Eddy Building – Detached Addition : Addendum #2

ADDENDUM #2:

This Addendum No. 2 forms a part of the Contract Documents and modifies the original Drawings and Specifications dated September 6, 2024, as noted below. Acknowledge receipt of this addendum in the space provided on the Bid Form. Failure to do so may subject bidder to disqualification.

NEW PROJECT FOR
NC DEPT. OF AGRICULTURE & CONSUMER SCIENCES
SCO ID#: 22-24471-02A
EADDY BUILDING DETACHED ADDITION
4300 REEDY CREEK RD., RALEIGH, NC 27607

S111

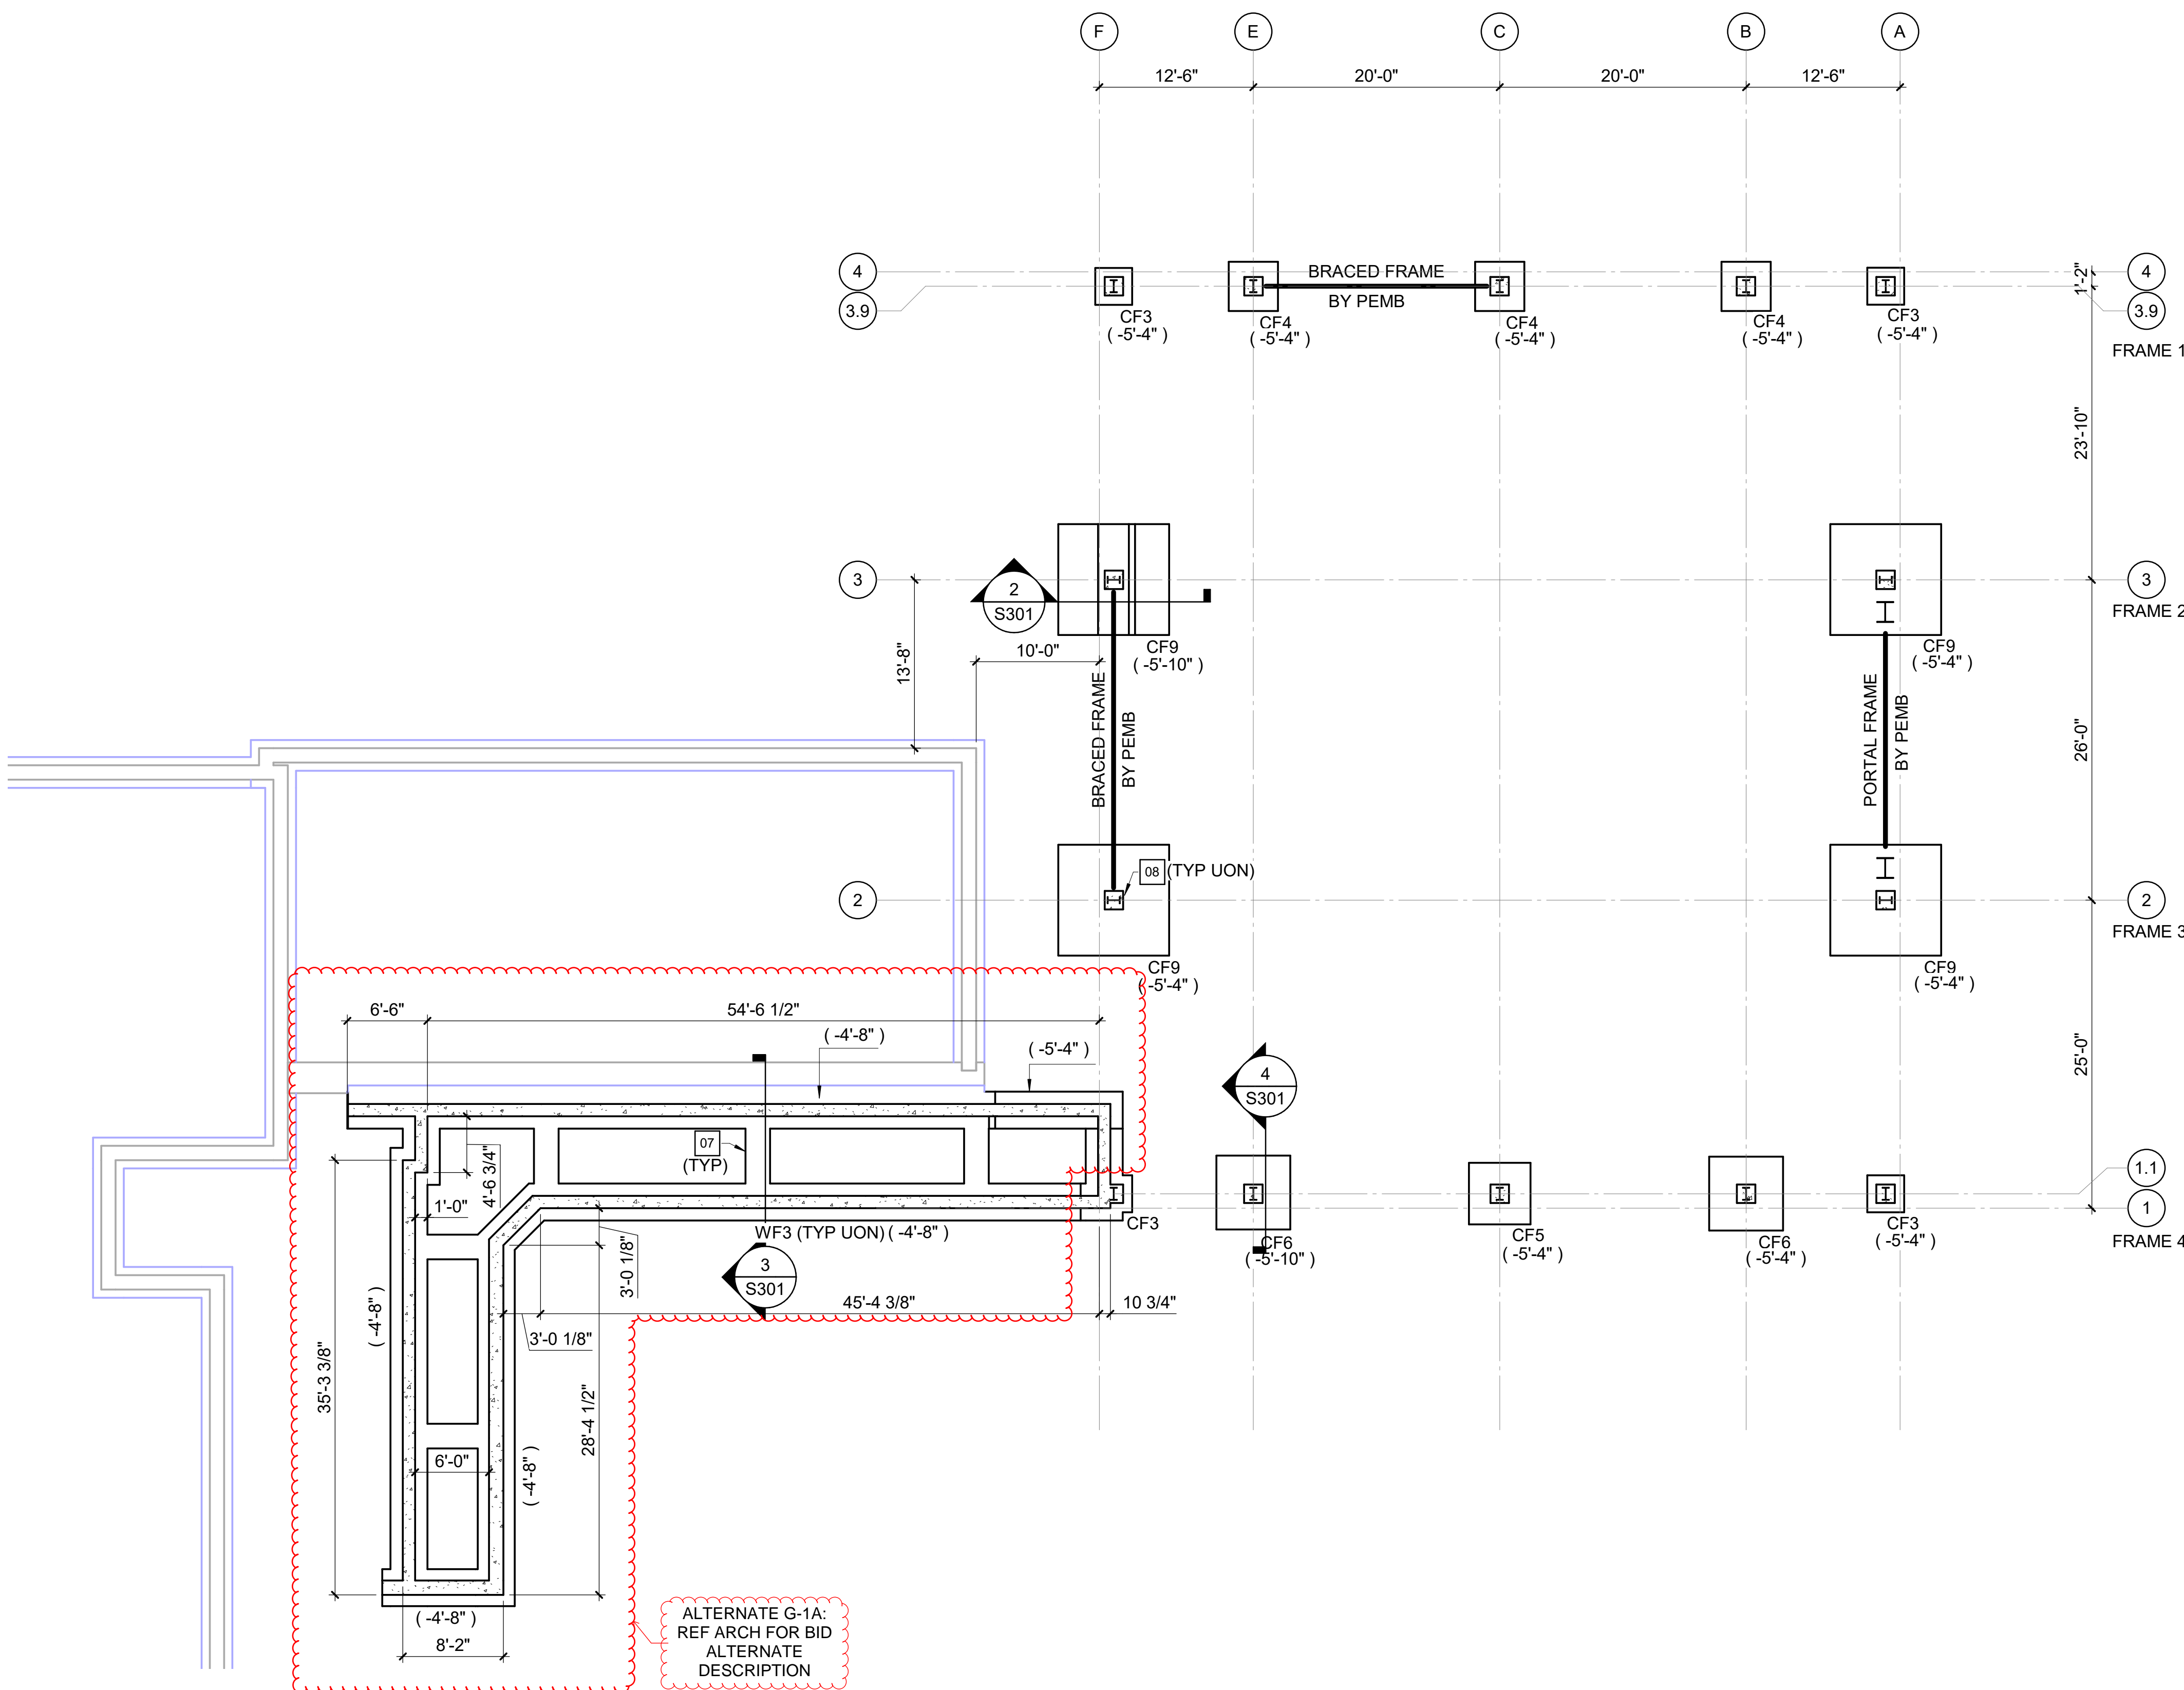
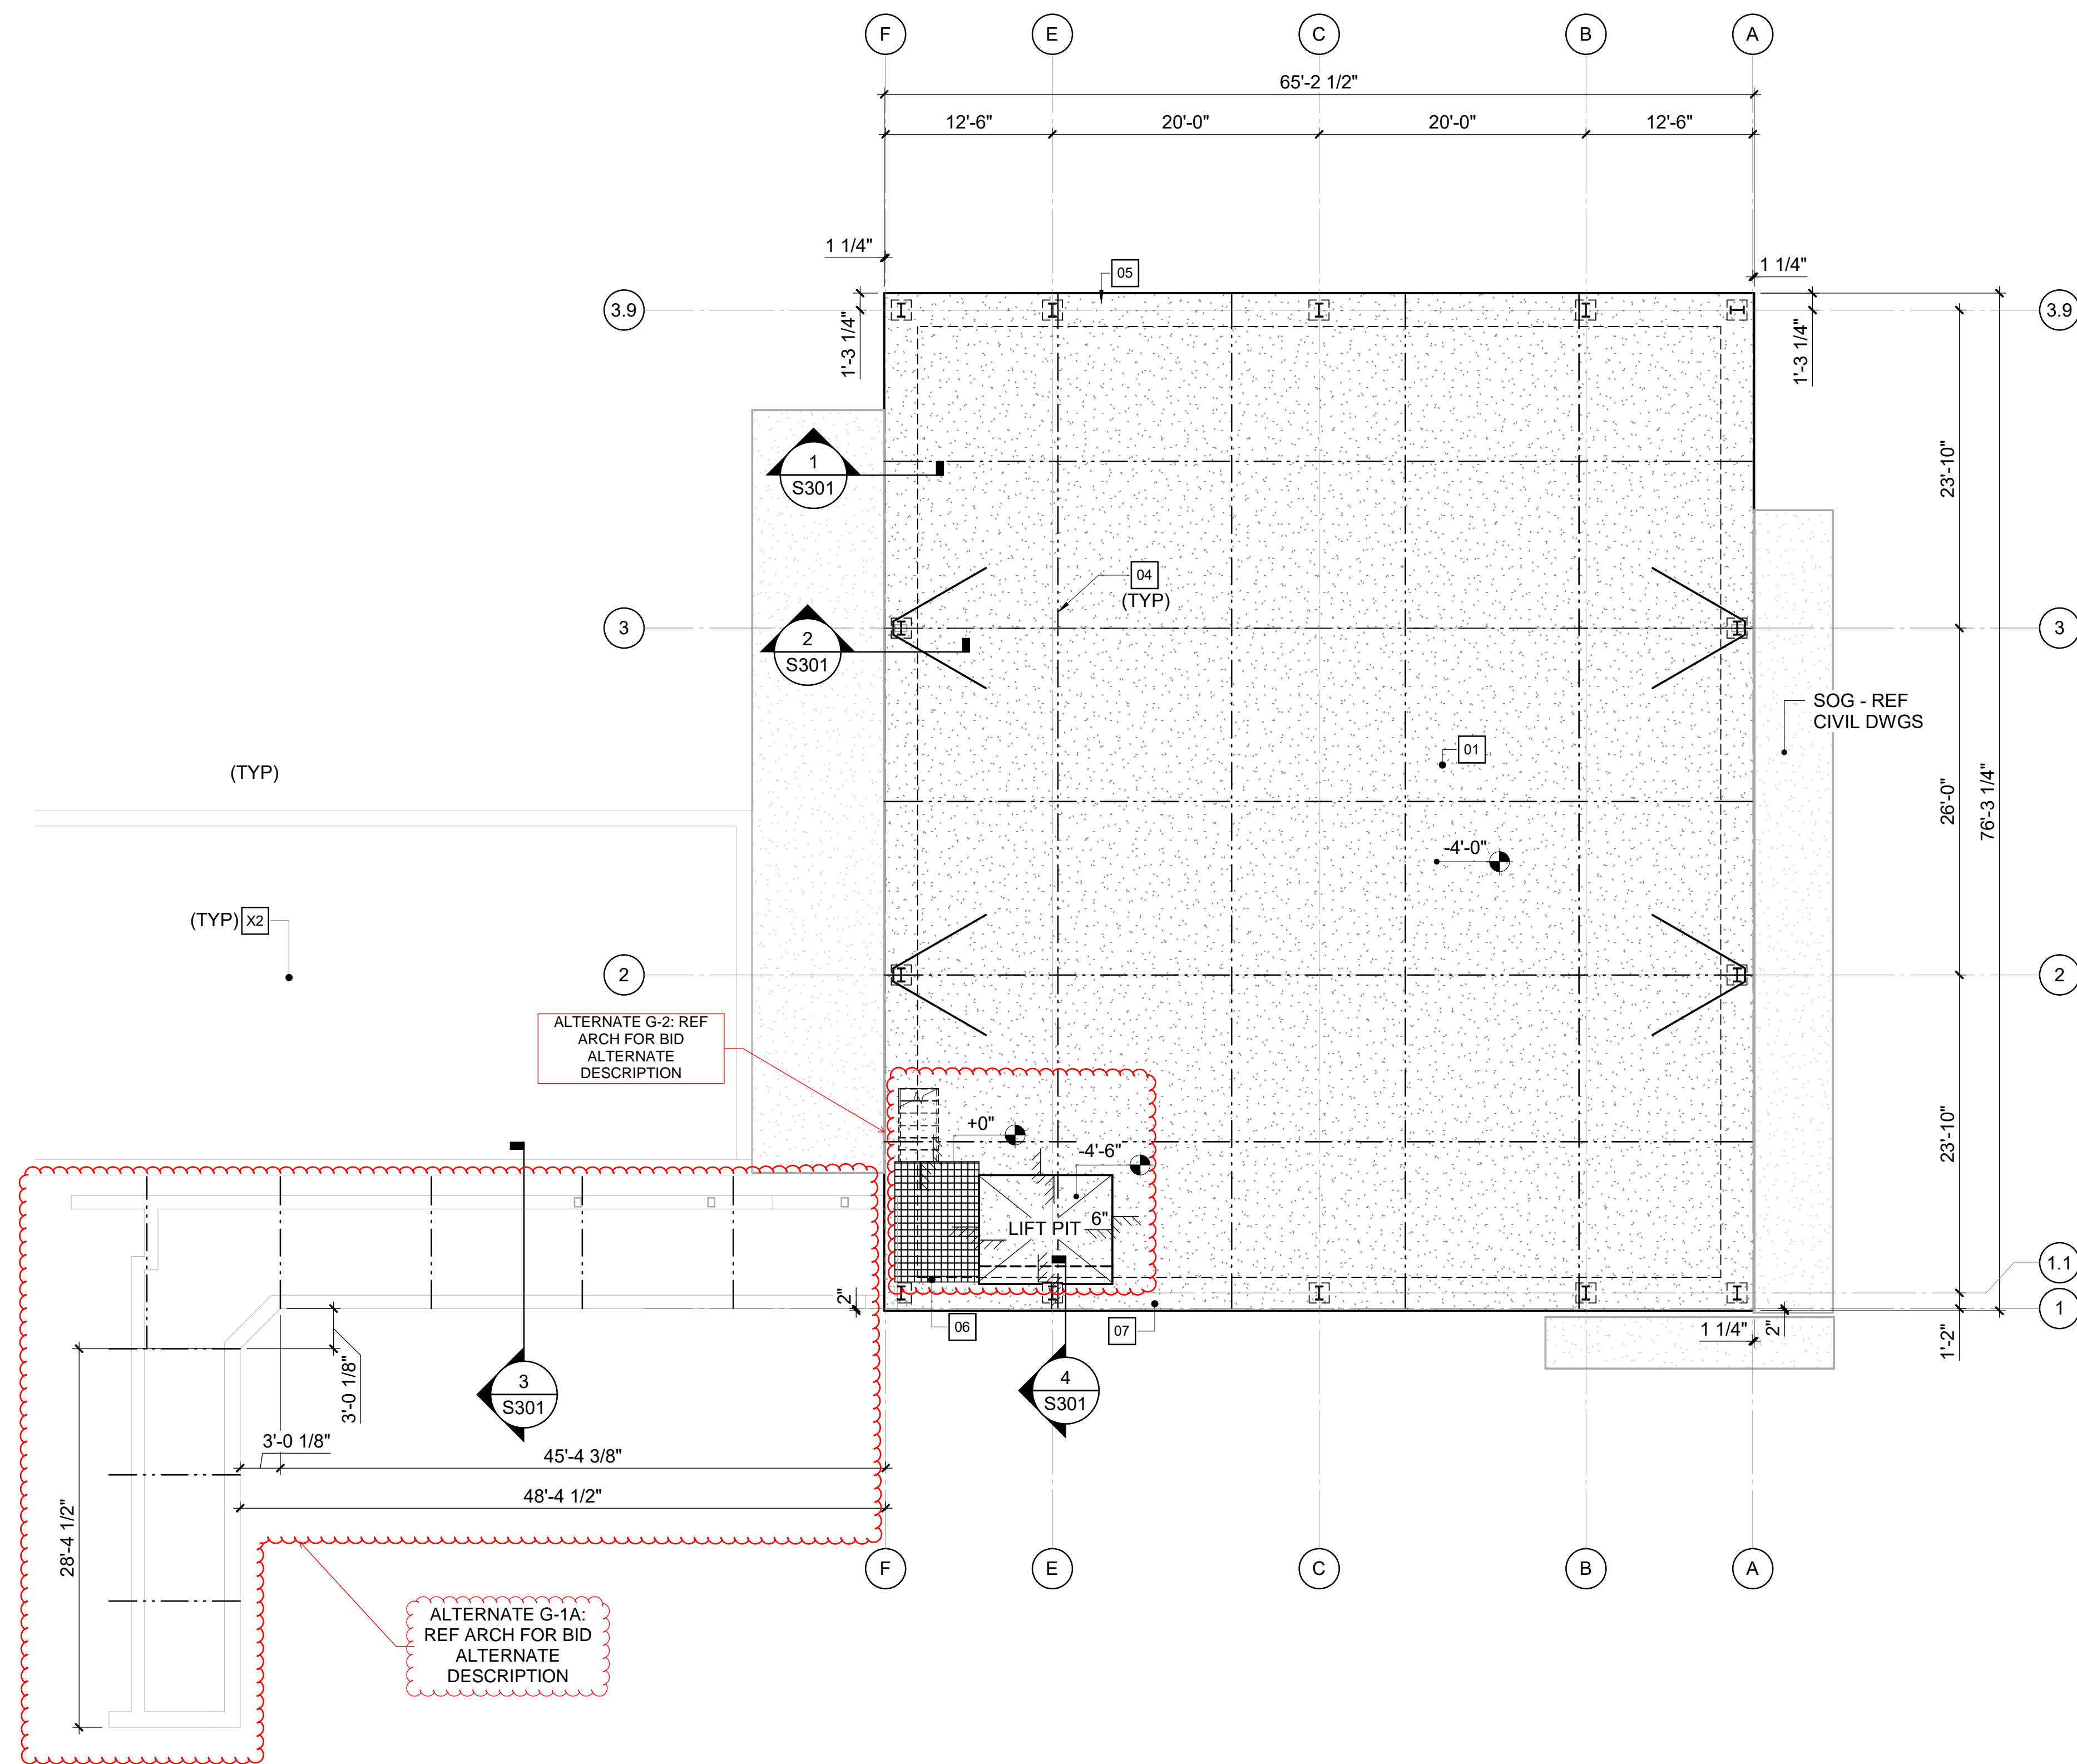
2. Question. Show alternates on ALL plan sheets including structural sheets. S drawings do not identify alternates.
 - o RESPONSE: Please see the attached marked up structural drawings for indications of what portions are part of various bid alternates.

S112

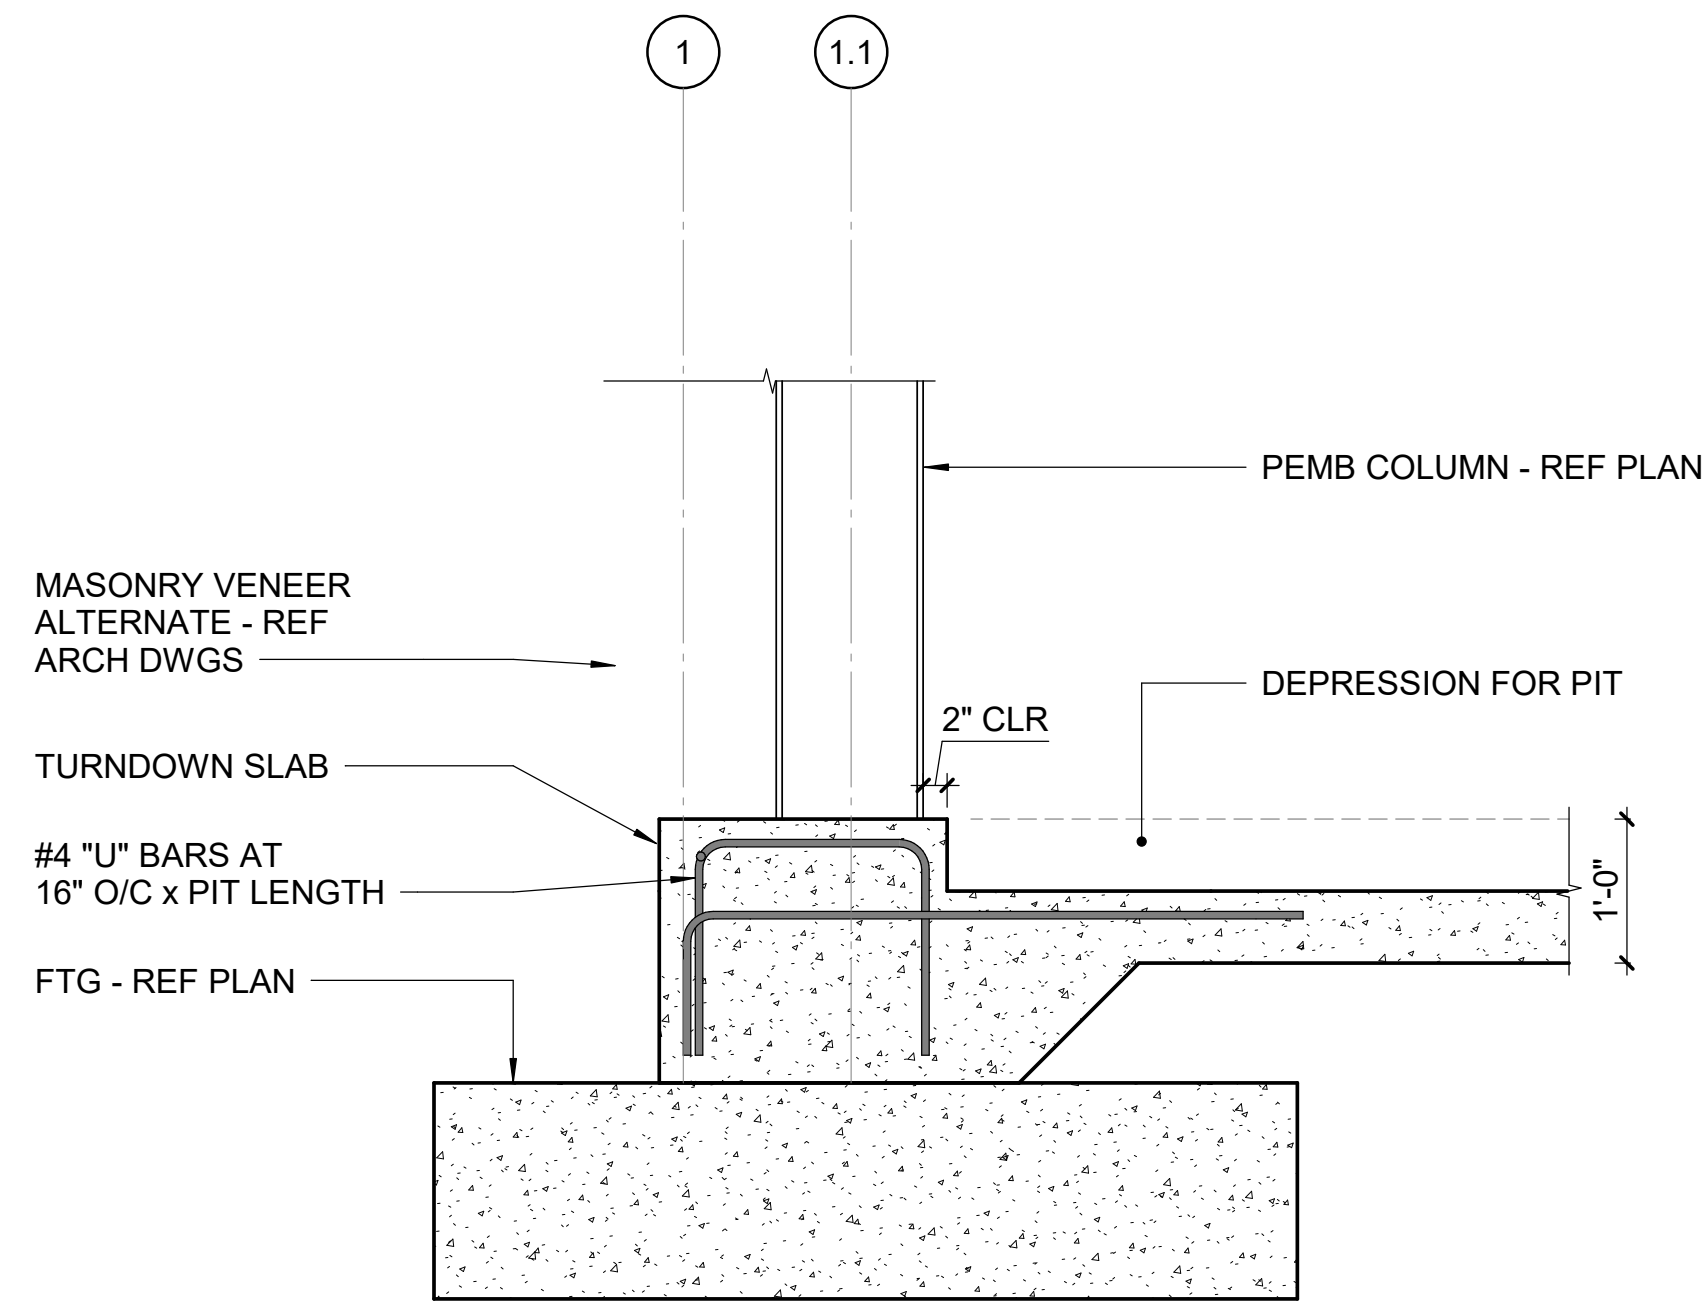
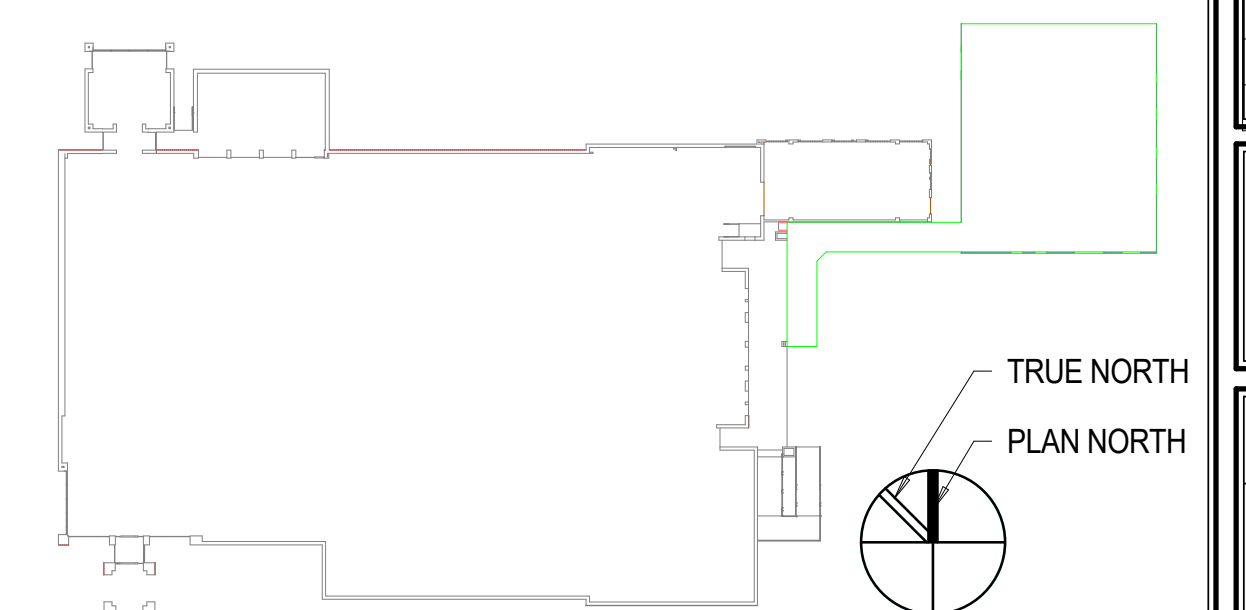
4. Need some clarification on the Alternate Platform. S112 – Note 6: Pre-mfg. galv steel platform 10x6' - S301 – Shows a concrete platform. Can you clarify this platform – steel or concrete?

- o RESPONSE: Key Note 6 on S-112 is calling out the manufactured galvanized steel platform landing at the top of the lift. This steel platform is interior to the building. Section 3/S-301 is a section through the exterior elevated walkway that is concrete (see section tag on S-112 for where this detail is taken).
